Merged Document Report

Application No.: PL8504

Plat of Roy Smith Plaza Block 1, Lot 8

**Preliminary Utility Map of
 Roy Smith Plaza
 Block 1, Lot 8**

Preliminary Storm Water Quality Management Plan of Roy Smith Plaza

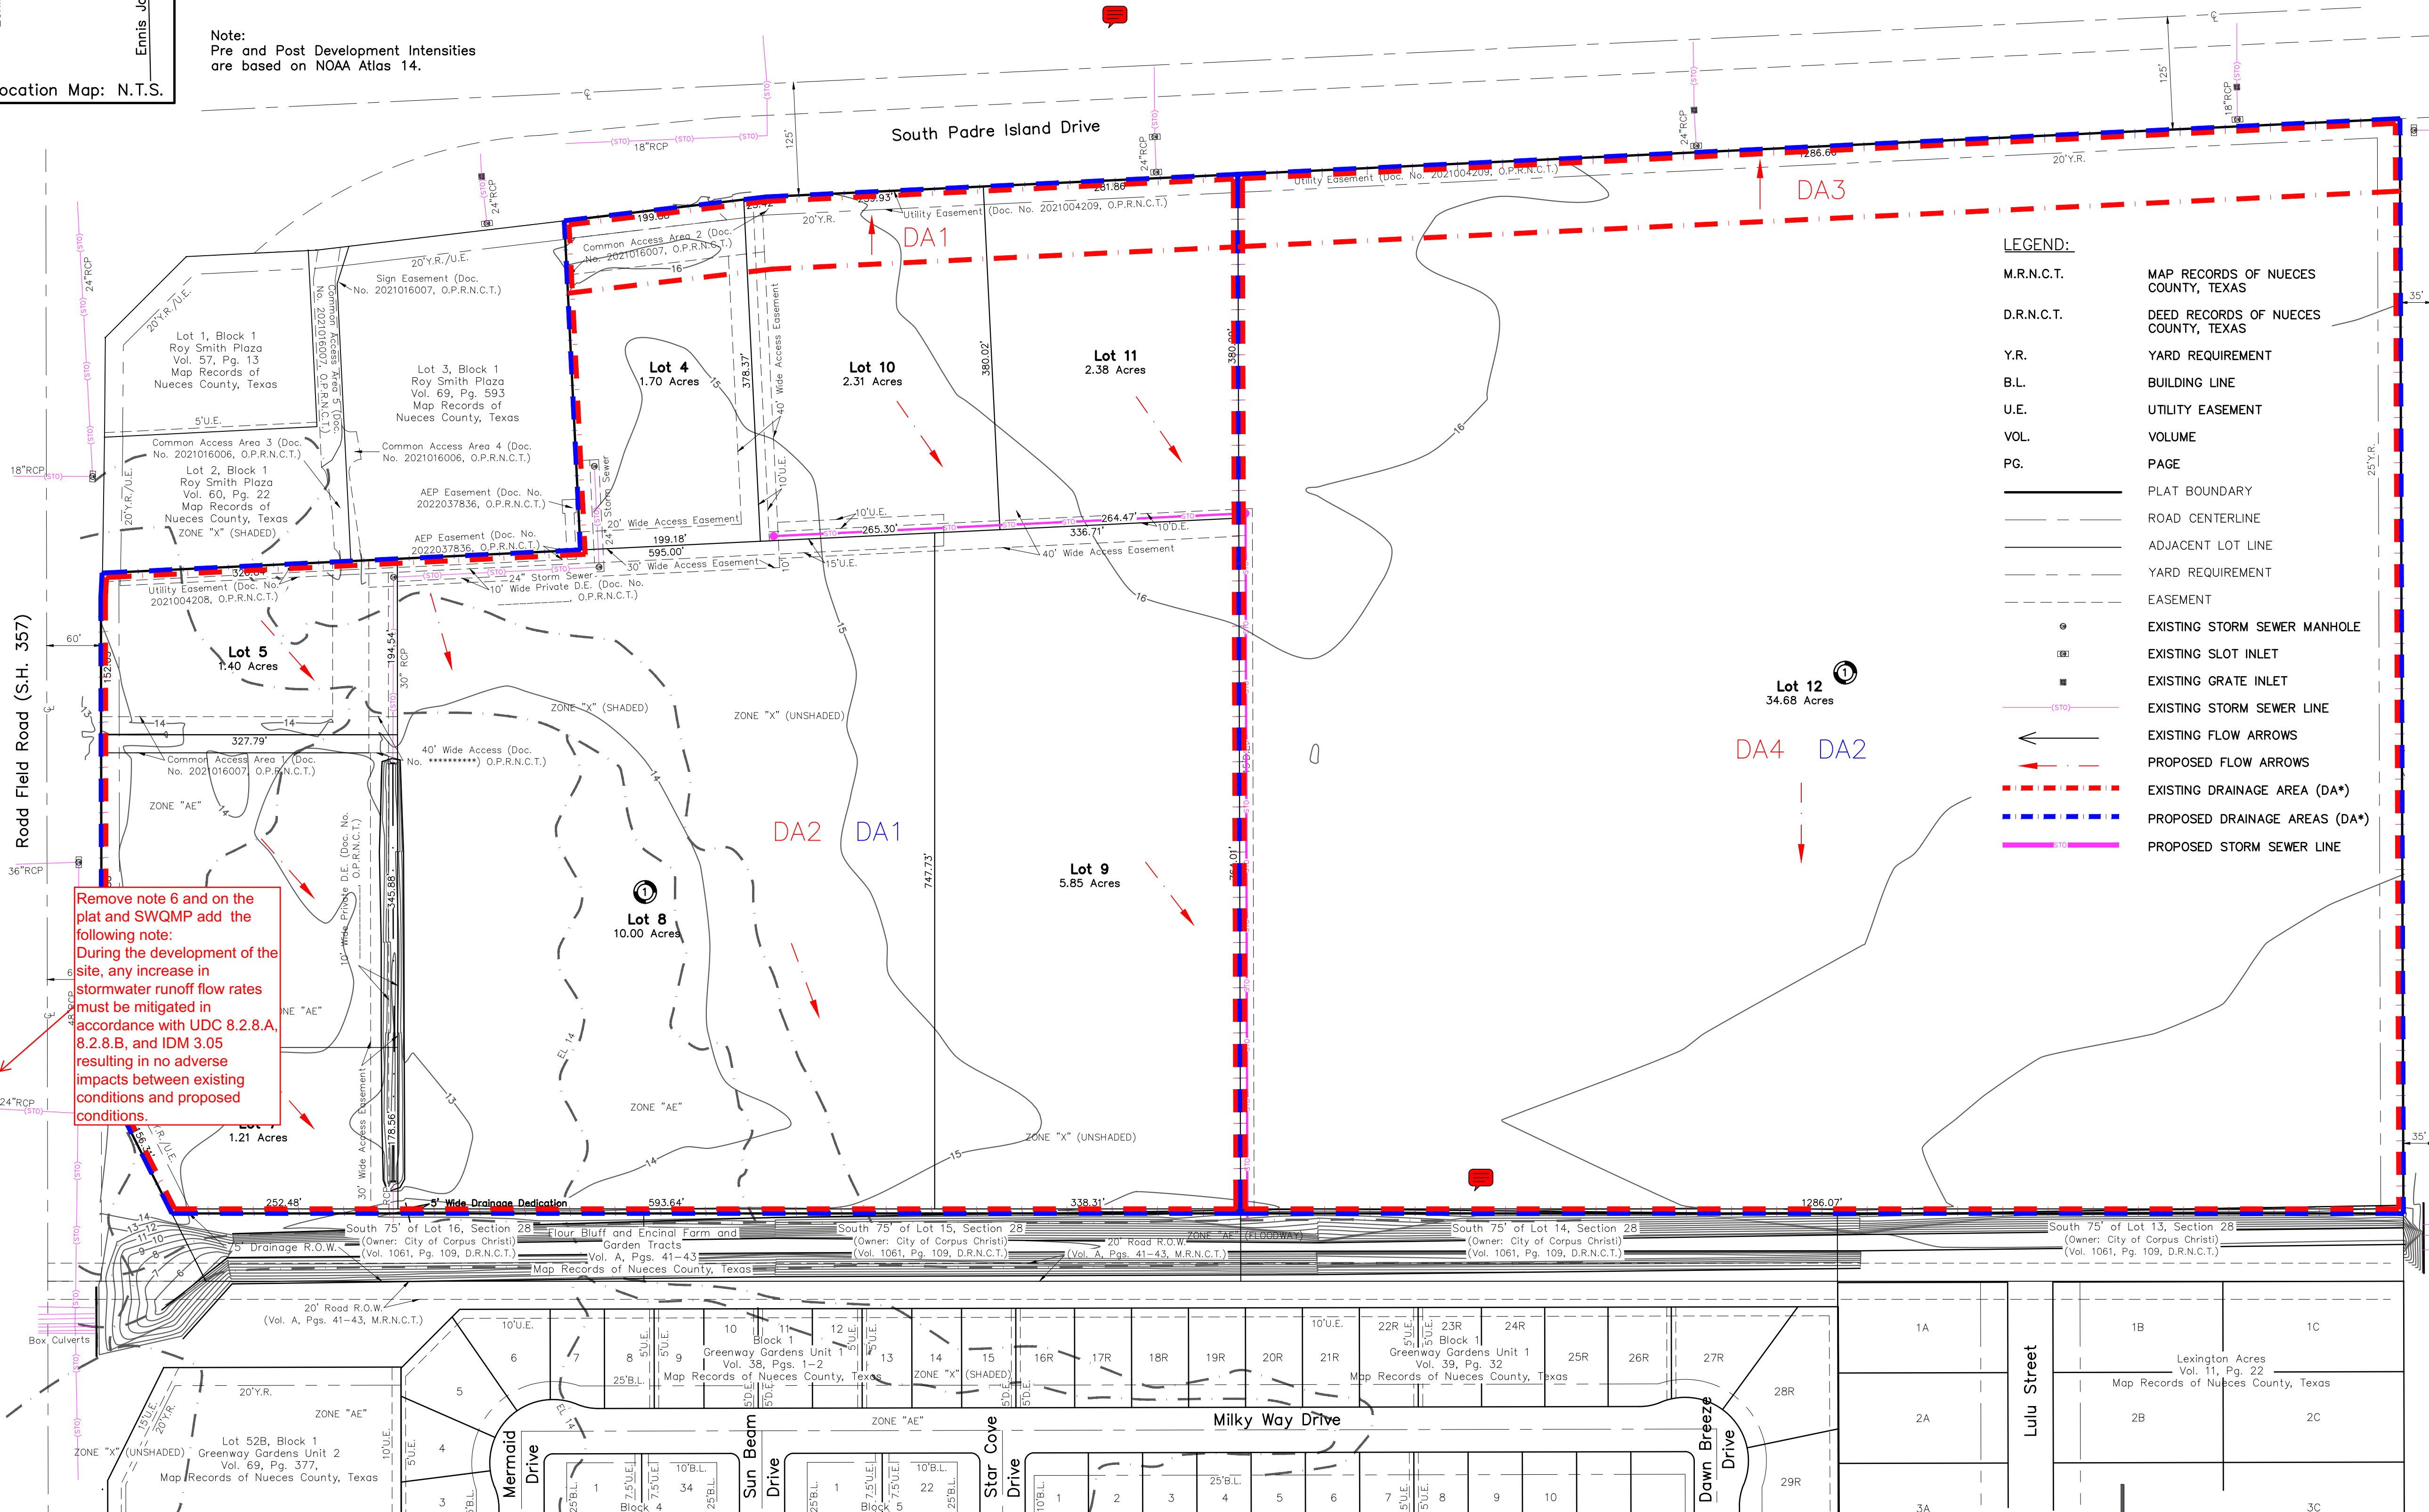
Comment ID	Page Reference	Annotation Type	Author : Department	Status	Review Comments	Applicant Response Comments
14	SWQMP	Note	Alex Harmon : DS	Open	<p>Show boundaries of existing wetlands on SWQMP and Plat for the following reasons:</p> <ol style="list-style-type: none"> 1. Approval from the USACE is needed prior to recordation/construction in wetland areas. Ensure the wetlands are not on site. 2. Per City of Corpus Christi - Code of Ordinances Ch 14, Art X, Sec 14-1003, a SWQMP should identify any environmentally sensitive area that is on the site, or that would be sensitive to storm water pollution from the site. 	
19	SWQMP	Note	Alex Harmon : DS	Open	<p>TXDOT: •No increase in storm water discharge to State right-of-way shall be accepted by TxDOT. •TxDOT Permits will be issued in accordance with the access management standards and all applicable state and federal laws, including rules and regulations. Access connection spacing, materials, geometrics, accessibility, and other design specifications will be considered, as well as the impact on drainage and hydraulics, utility location or relocation, and the environment that will result from the requested construction of an access connection. 43 Tex. Admin. Code § 11.52 (2020). •Drainage improvements shall accommodate runoff from the upstream drainage area in its anticipated maximum "build-out" or "fully developed" condition, and shall be designed to prevent overloading the capacity of the downstream drainage system •If the owner responsible for maintenance of the permanent stormwater or water quality control fails to maintain the control to TXDOT ROW, the owner shall correct the problem.</p>

Remove note 6 and on the plat and SWQMP add the following note:
During the development of the site, any increase in stormwater runoff flow rates must be mitigated in accordance with UDC 8.2.8.A, 8.2.8.B, and IDM 3.05 resulting in no adverse impacts between existing conditions and proposed conditions.

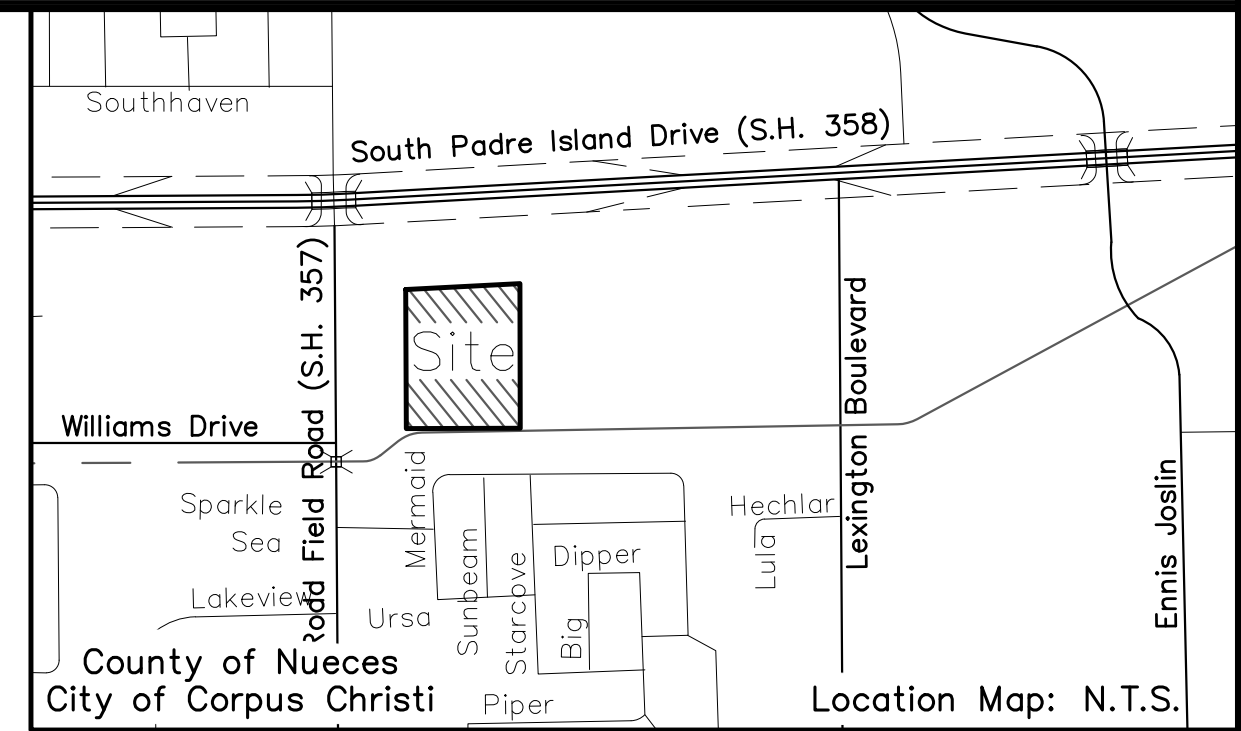
9	P001	Callout	Mark Zans : LD	Open	Remove Al Raymond name. Insert Michael Dice Interim Director	
20	P001	Note	Mark Zans : LD	Open	As of this date (11/1/2024) many of the open comments from the preliminary plat still apply with this plat. Please check the merged document report from preliminary plat application that are open comments.	
8	P002	Note	Mark Zans : LD	Open	Provide doc. numbers for DE, AE, and UE for the easements shown.	
12	SWQMP	Callout	Alex Harmon : LD	Open	Remove note 6 and on the plat and SWQMP add the following note: During the development of the site, any increase in stormwater runoff flow rates must be mitigated in accordance with UDC 8.2.8.A, 8.2.8.B, and IDM 3.05 resulting in no adverse impacts between existing conditions and proposed conditions.	
13	Utility Map	Note	Mikail Williams : WTR	Open	Water construction is required for platting (UDC 1.2.1.D & 8.2.6; Water Distribution Standards). Please show how Lot 9 will receive water service.

Remove Al Raymond name.
Insert Michael
Dimitrakou
